## SERVICE BULLETIN

EQUIPMENT TYPE KWM-1

BULLETIN NO. 1

**SUBJECT A: Improvement in Calibrator Operation****B: Spurious Outputs of KWM-1****C: Transient in Speaker when Switching from Receiver to Transmit****D: Hum in Speaker when AF Gain Control is Advanced in CW Operation****E: "Tweets" in Audio Output Caused by DC Power Supply**

Figure 1. Wiring Location of L1 Shield Can

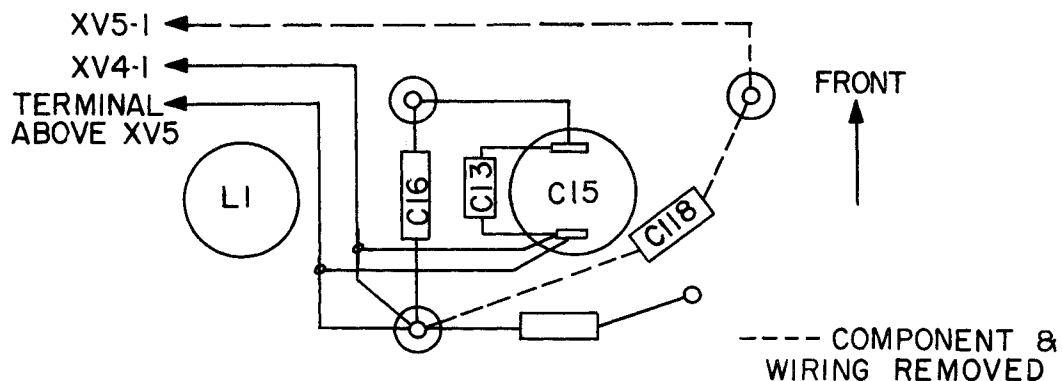
4. Remove 1 uuf capacitor, C118, and coax lead from C118 to XV1 pin 5. C118 and coax

lead are connected to insulated terminal mounted on trimmer capacitor. Discard coax and capacitor. See figure 1.

7. Install a five inch length of coax cable (425 0926 00) from terminal directly over XV5 pin 9 (installed in step 5) to insulated terminal to which C16 and coax cable to XV4 pin 1 is connected. See figure 1. Ground coax shield to C15 as shown in figure 1. Ground shield at C15 end only.

Figure 2. Location of Number 29 Hole for Installation of Insulated Terminal

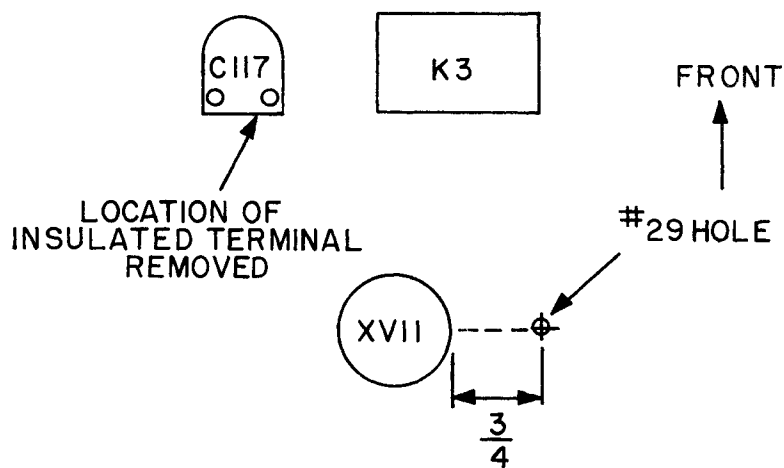
13. Unsolder .001 capacitor and coax from the insulated terminal mounted on "Cal Zero"

capacitor, C117, (insulated terminal on K3 side of capacitor) and remove insulated terminal from capacitor. See figure 2.

15. Drill new hole as indicated in figure 2. Care should be taken not to damage wiring and other components when drilling this hole.

Figure 3. Partial Schematic V1, After Modification

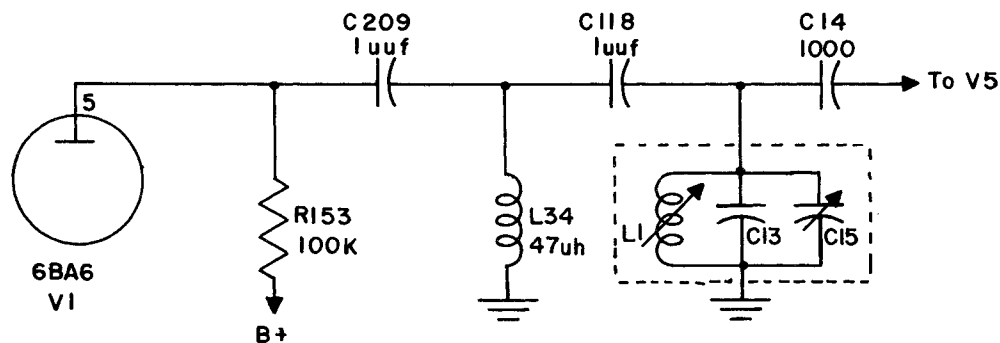
19. Check circuit for correct wiring as shown in Figure 3.

Figure 4. Location of Number 29 Hole for Installation of Insulated Terminal

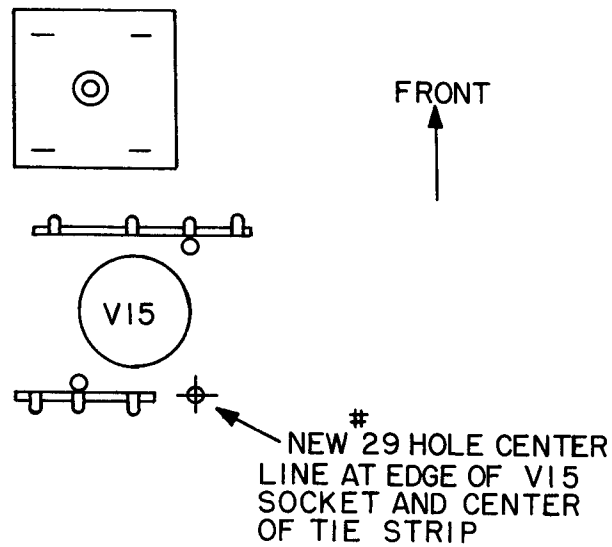
2. Carefully drill a number 29 hole next to tie strip at rear of XV15 as shown in figure 4. Care should be taken not to damage cable harness.

Figure 5. Partial Schematic V15, After Modulation

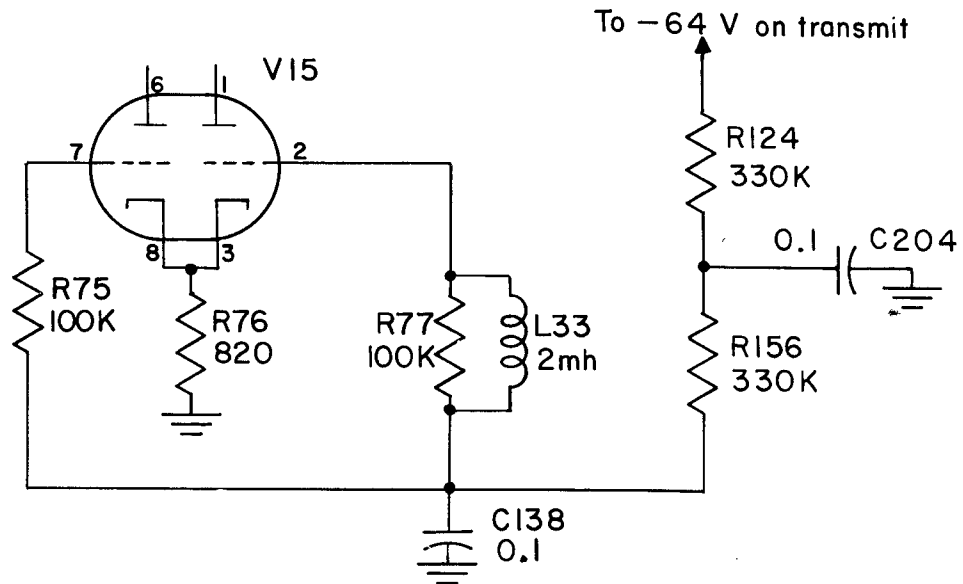
9. Refer to figure 5 for schematic of completed modification.

Figure 6. Location of Components, Bottom View

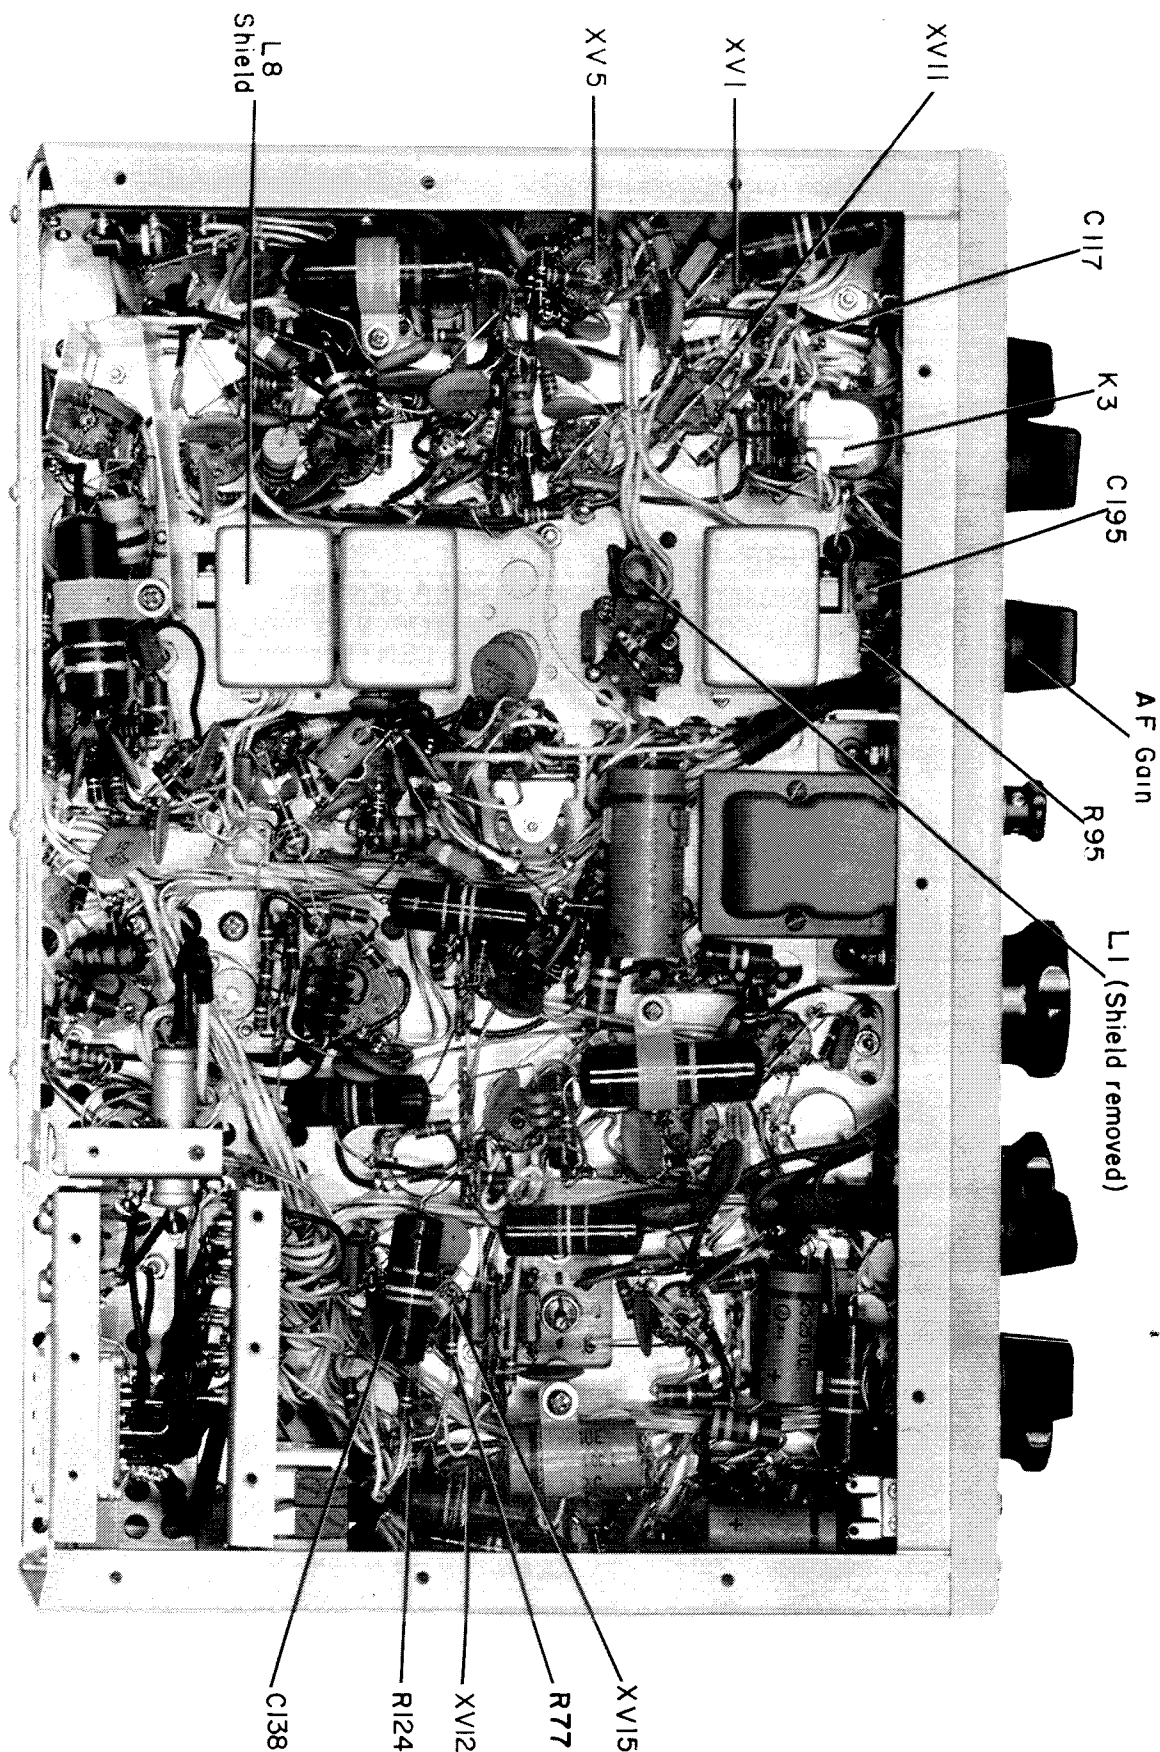
3. Remove L1 coil can. (L1 can is located beside XV4 and is second can nearest front of the unit). See figure 6.

1. Remove the 330K 1/2 watt resistor, R124, connected to terminal on terminal strip behind XV12. (See Figure 6). R124 should be removed by cutting from the strip and discarded.

1. Remove the L8 shield can. See figure 6.
2. Install five ground clips (220 1323 00) around edge of the can and replace in original location. Make sure that can mounting nuts are tight.

6. Connect .1 uf capacitor, C204, (931 0299 00) from insulated terminal installed in step 3 to same ground as C138. See figure 6.

In earlier models of the KWM-1, some hum could be heard if the AF Gain control was run high when in CW operation. This is actually a low frequency oscillation in the sidetone circuit and may be eliminated by the following modification. Units that have this modification installed will have a four terminal tie strip mounted directly behind the RF and AF gain controls with a 470 K 1/2 watt resistor connected in series with a 220 uuf capacitor mounted on the strip. Figure 6 shows the modified circuit.
